City of Surrey  
**PLANNING & DEVELOPMENT REPORT**

File: 7911-0173-00

Planning Report Date: April 22, 2013

**Respond to ADVISORY DESIGN PANEL STATEMENT OF REVIEW**  
**3-storey commercial building**  
**6321 King George Blvd., Newton**  
**File No. 7911-0173-00**

Sheet	1" = 20'	of	1
Date	DEC. 2012	Project Title	MASKEN PROFESSIONAL CENTRE 6327 KING GEORGE BLVD. SURREY, B.C.
Revision	01	Project No.	12-1279
		Drawn By	A101
		Checked By	
		Design	
		Date	
		DP. REVISION	
		DATE	
		DESCRIPTION

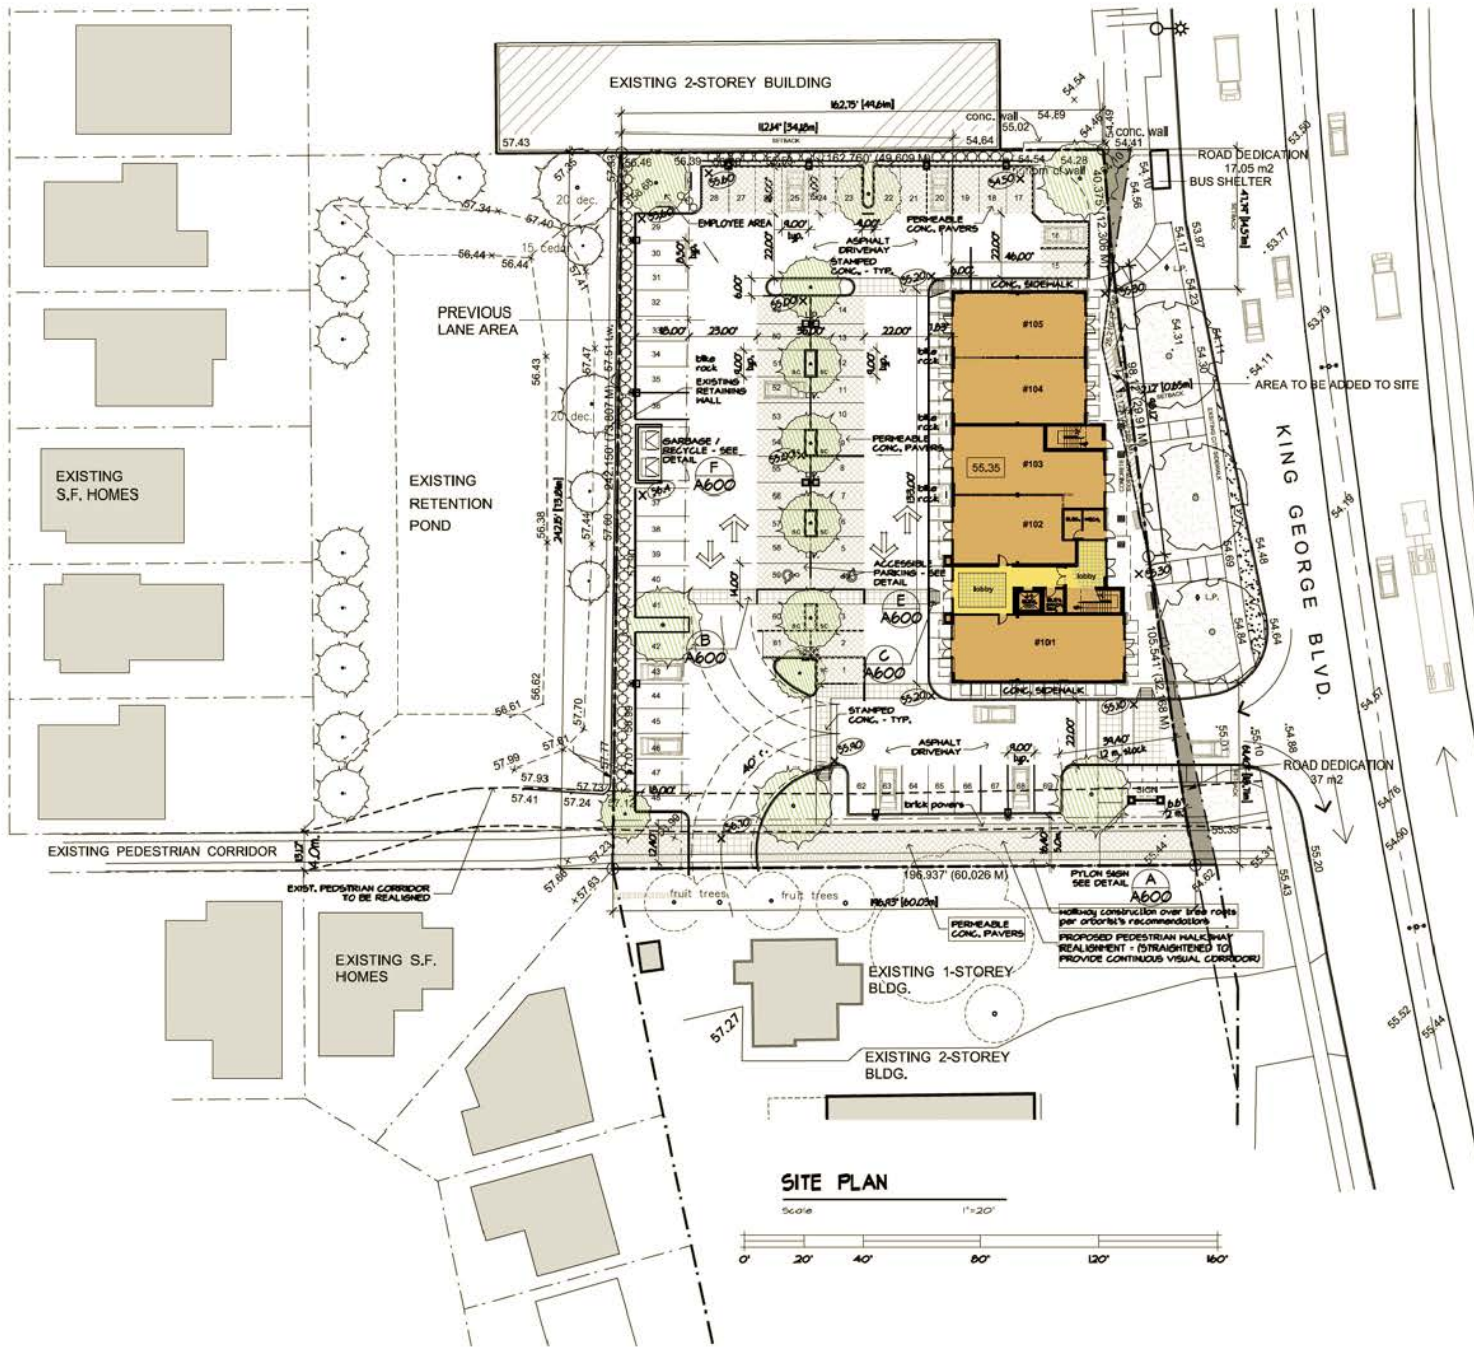
-Site lightings .

- Employee area: introduce furniture around front to allow seating.
- Landscape design suits the site.
- Could be some benches around the building. Perhaps a couple in front.
- Planting bed can it be used to catch storm and rain water.
- Permeable pavers/parking area trees. Street trees.
- Look at different permeable materials in lieu of asphalt path at south.
- Look at hangover parking stalls in centre to allow swale (permeable).

Site lightings are specified on site plan with appropriate shields, baffles, louvers cut-off features to be used to prevent light overspill to nearby residence and into the sky, and glare from the light source

- Furniture / benches are added to employees lunch area.
- Permeable pavers are provided in lieu of asphalt path at south.
- Permeable pavers are provided at centre parking aisles.

east elevation - to King George Blvd.

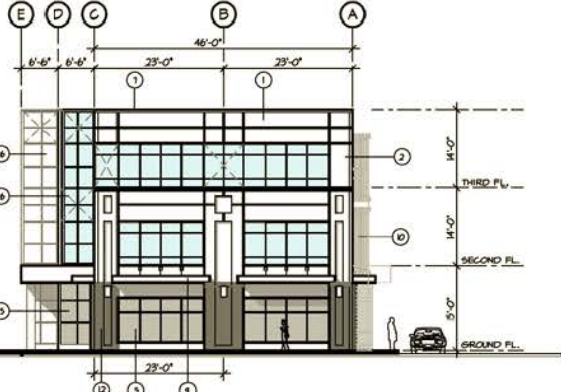
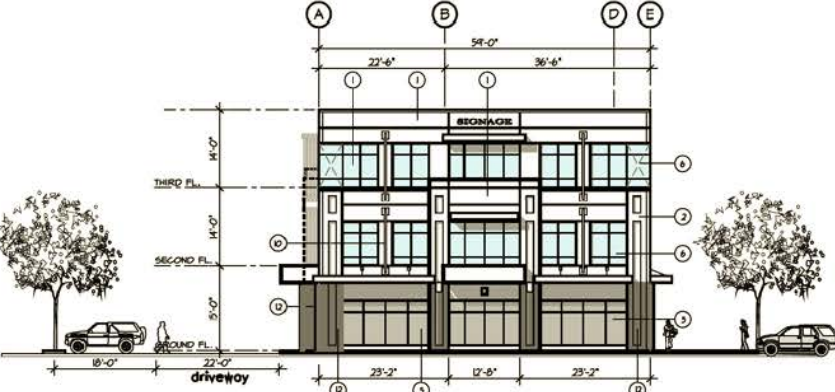
- Would like to see richer materials—brick at base?

- Much improved; would like to see more articulation of architecture elements if possible.

- Brick veneers are added to all elevations at ground floor level .
- Renderings are much better and elevations look nicer but imply a lot of relief on building. Understand limitations of tilt up.
- Stair glass towers on left seems to be flush, on right has a setback. Get a substantial setback so materials are articulated.

- Position of glass towers are adjusted to provide articulation.
- Push or recess the windows in for a recess or relief.

- All punch windows are recessed to create shadows and relief.
- West elevation – more regularly spaced vertical sunscreens.

- More sunscreens are added.
- King George Boulevard location – need to define building entry better as it is a bit lost in the arcade. Column locations don't match the plan.

- Consider additional material at base, especially facing King George Boulevard.

- Brick veneers are added to all elevations at ground floor level .

- Stair glass towers are adjusted to provide articulation.
  - Vertical fins look better and a relief on balconies.
  - Concrete is good material, but tilt ups are like a painted surface.
- ### Response:
- Reveals will be increased from 3 /4 in to 1 ¼ to create shadows.

- Canopy size and column locations are adjusted to emphasize entrance.
  - Define west lobby entry better. Looks similar to north entry bay.
- ### Response:
- West entrance enhanced with protruded enclosed lobby , canopy and signage.

- Brick veneers are added to all elevations at ground floor level .

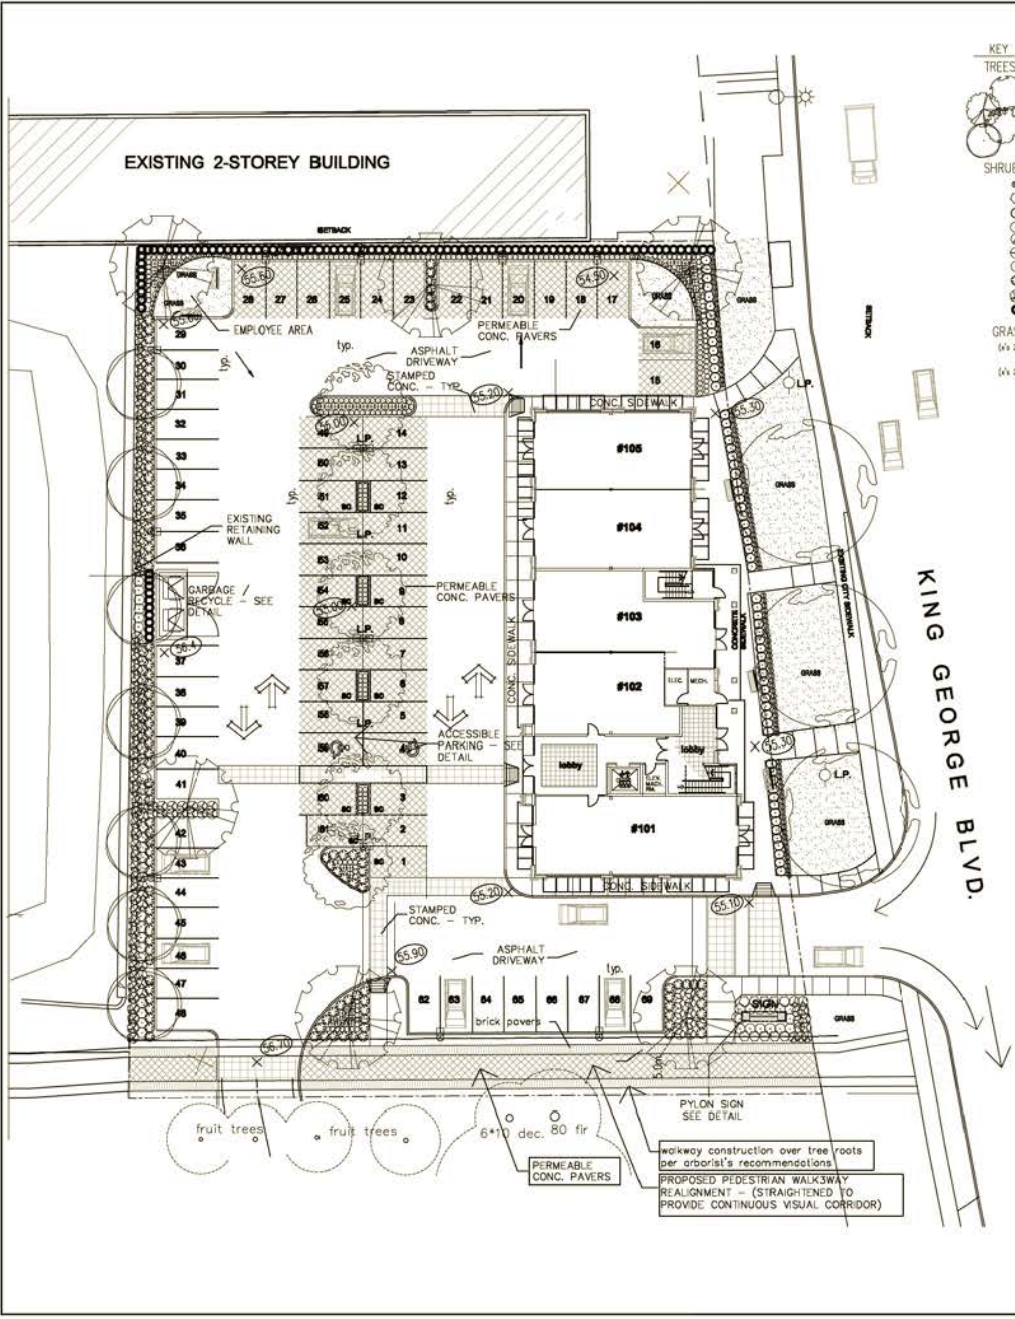
-Building Fascia signage

Building Fascia signage with dimensions, types and area added to the sets.
